Project: 23-061 DRIVEWAY CHANGE ORDER
Description: PRIMROSE CANAL DRIVEWAY AT
339 ST JOHN STREET

Revised Plan Set Drawings

PRIMROSE CANAL CLEANING AND IMPROVEMENTS

COUSINS CANAL
PLAN AND PROFILE
PHASE 1A

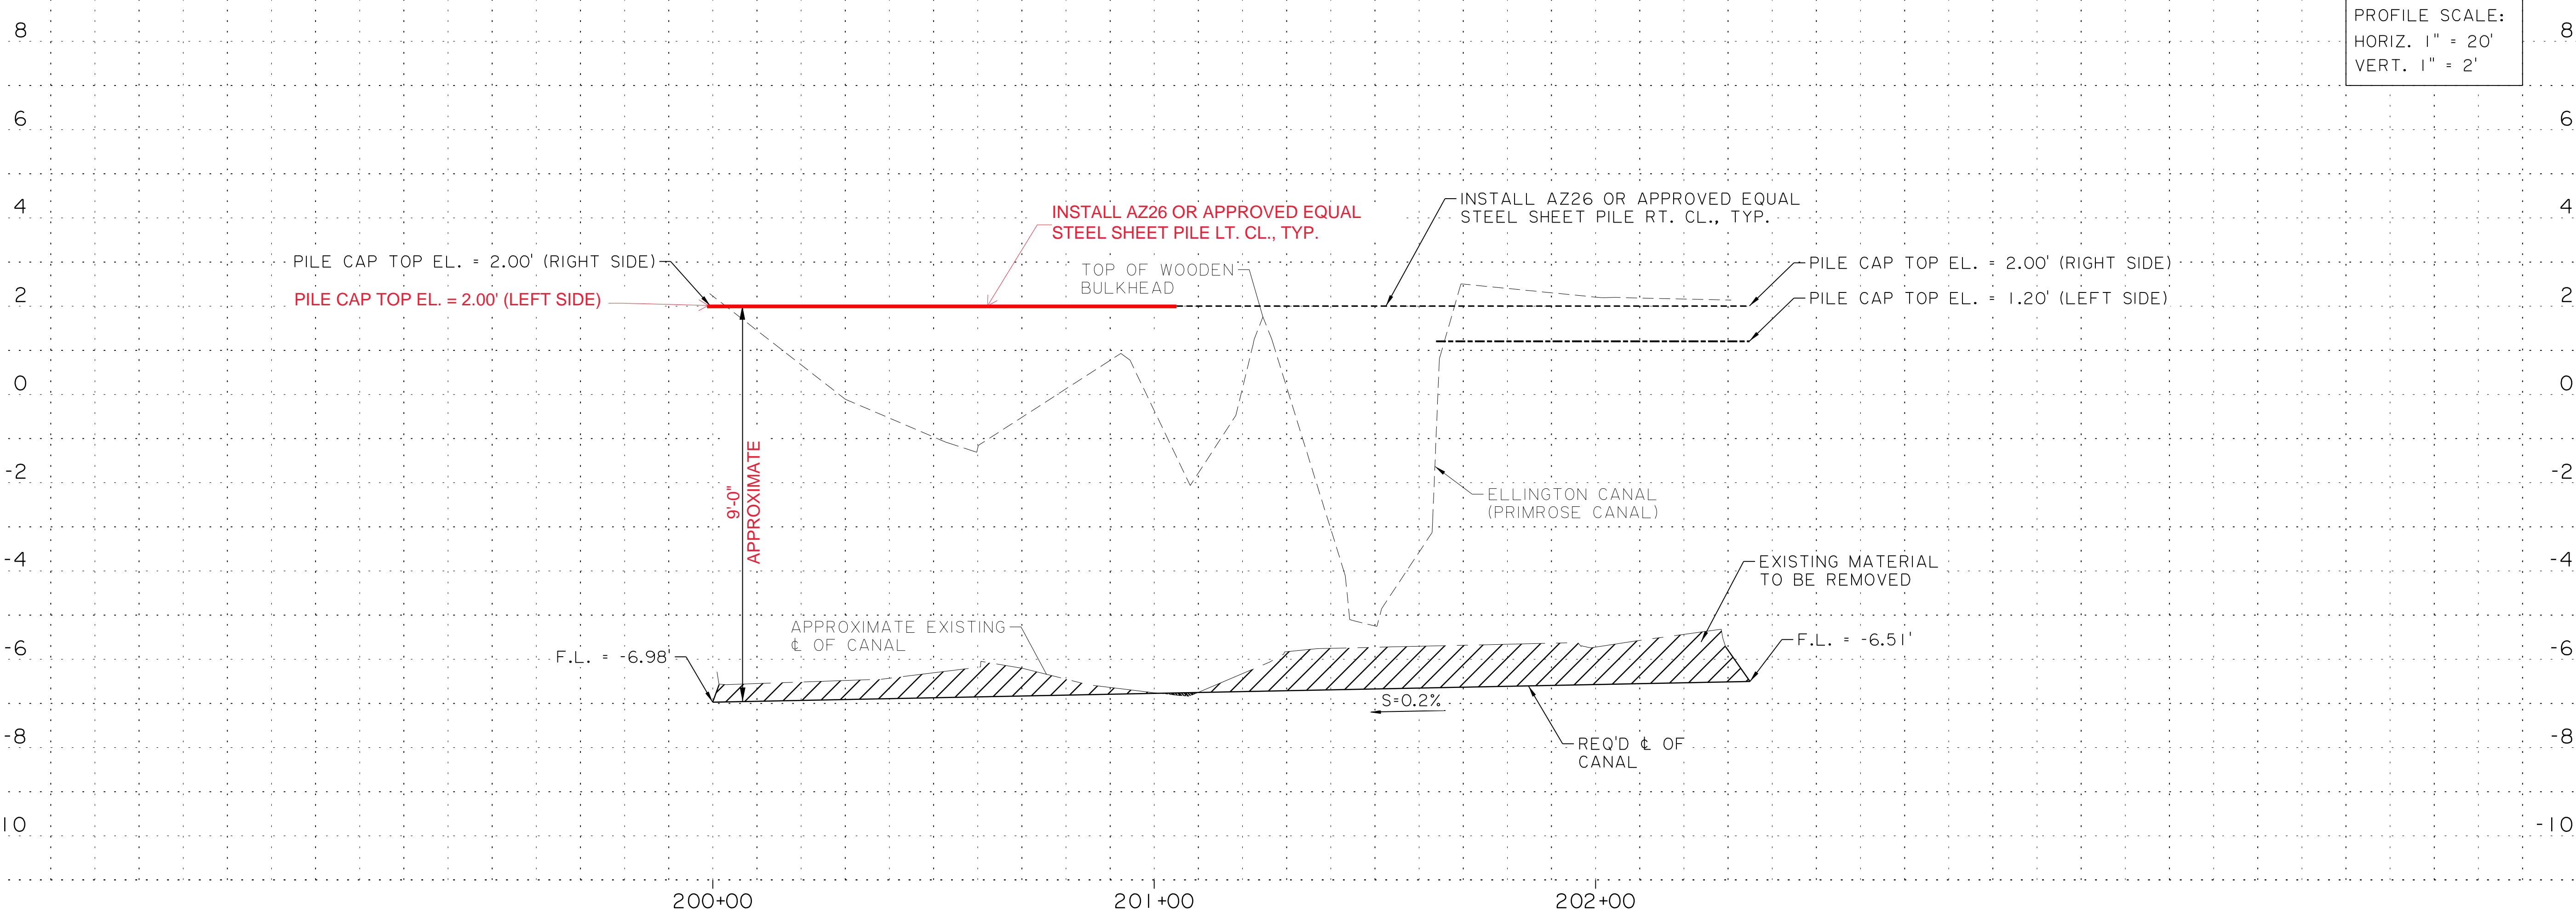
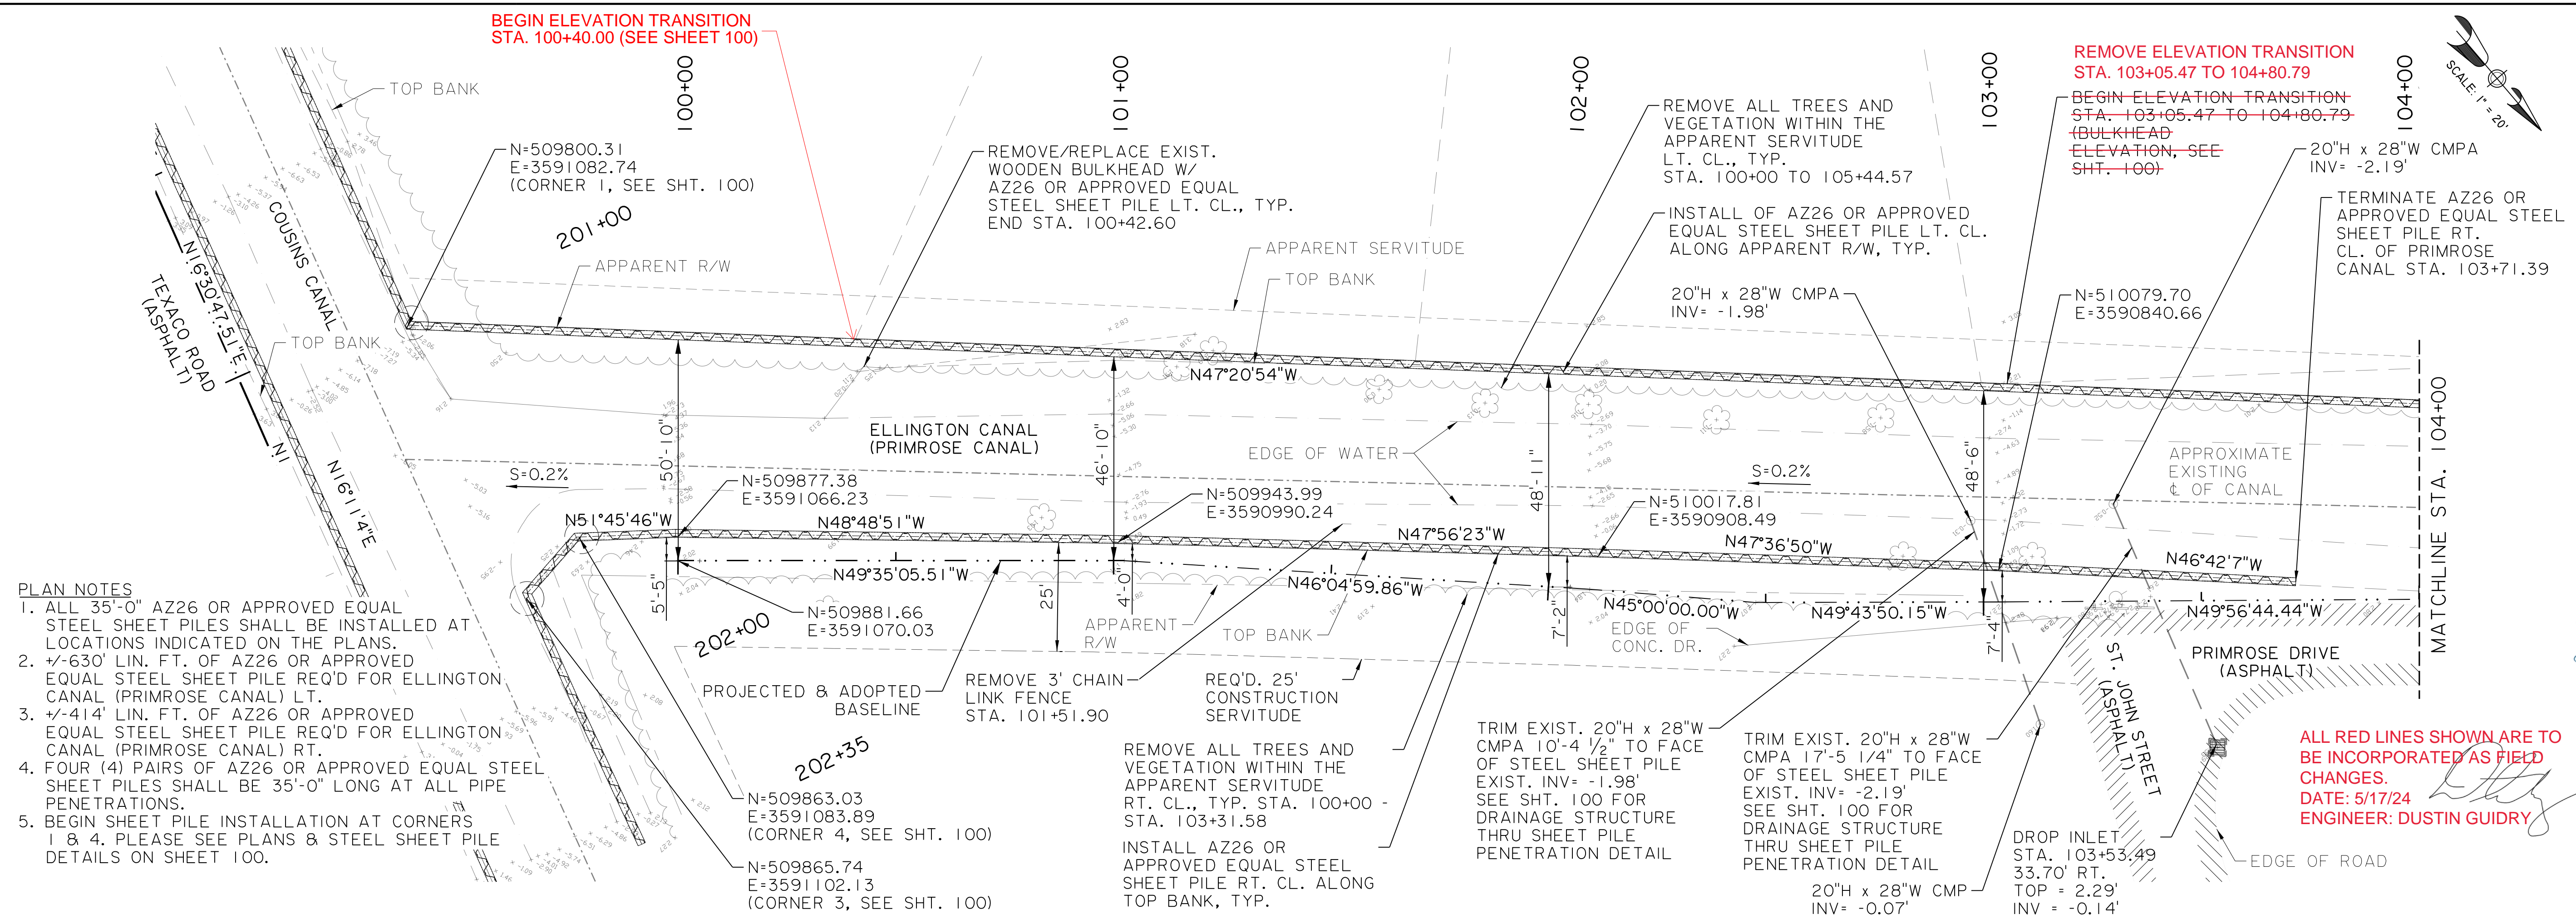
ALL RED LINES SHOWN ARE TO BE INCORPORATED AS FIELD CHANGES.
DATE: 5/17/24
ENGINEER: DUSTIN GUIDRY

ELLINGTON CANAL (PRIMROSE CANAL)
PLAN AND PROFILE
PHASE 1A

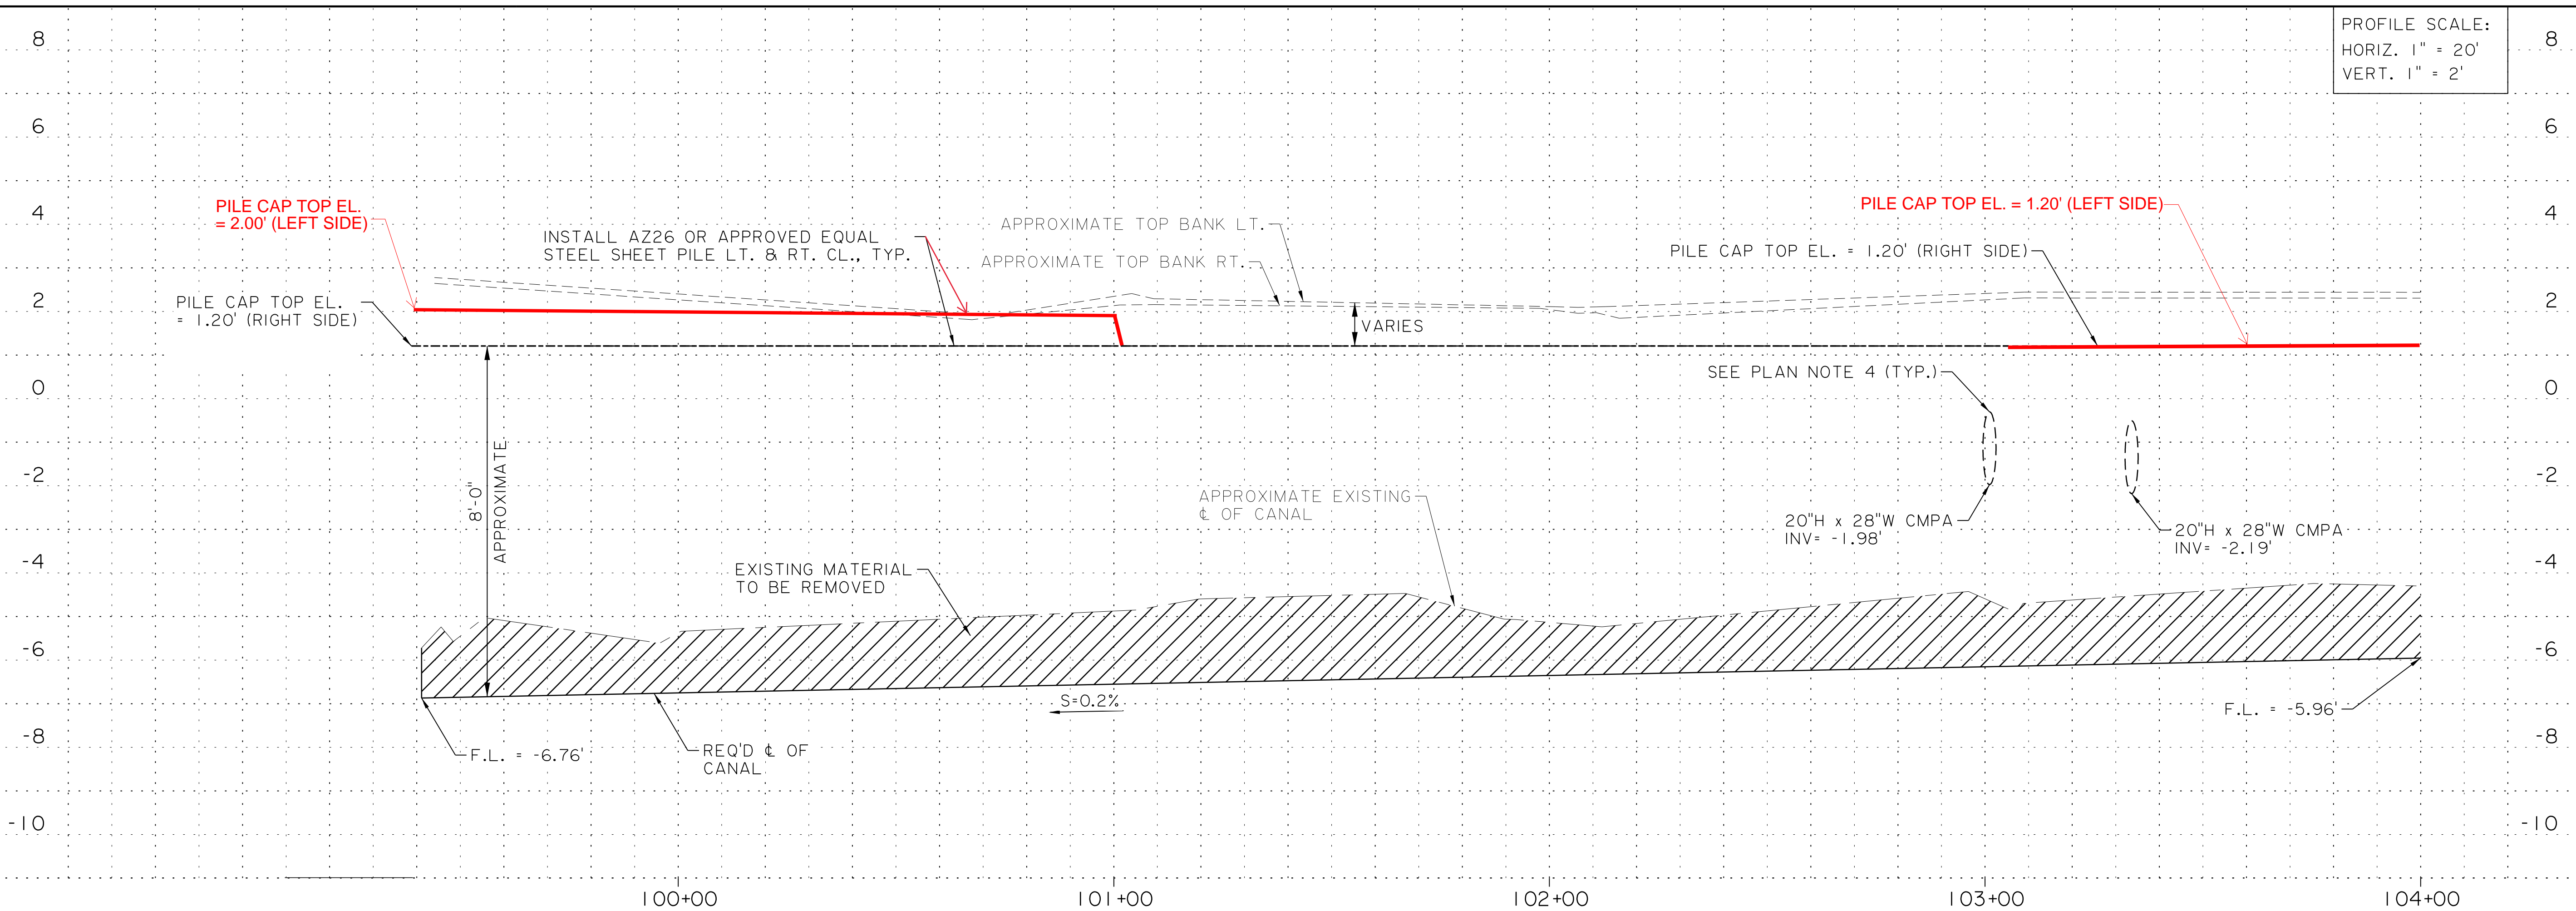
ALL RED LINES SHOWN ARE TO BE INCORPORATED AS FIELD CHANGES.
DATE: 5/17/24
ENGINEER: DUSTIN GUIDRY
